Errata

**NFPA 70<sup>®</sup>**

**2014 Edition**

**Errata No.:** 70-14-1

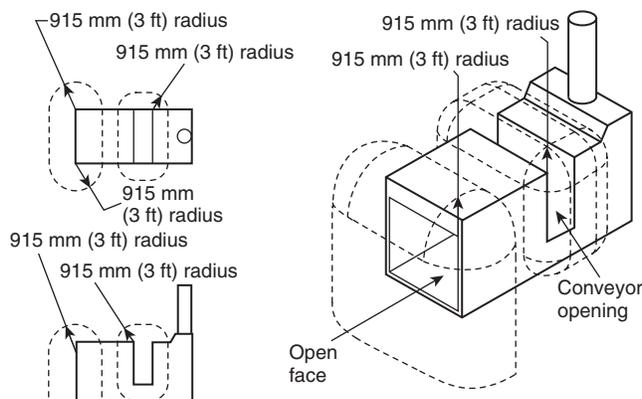
11. Replace Figure 516.3(D)(2) with the following:
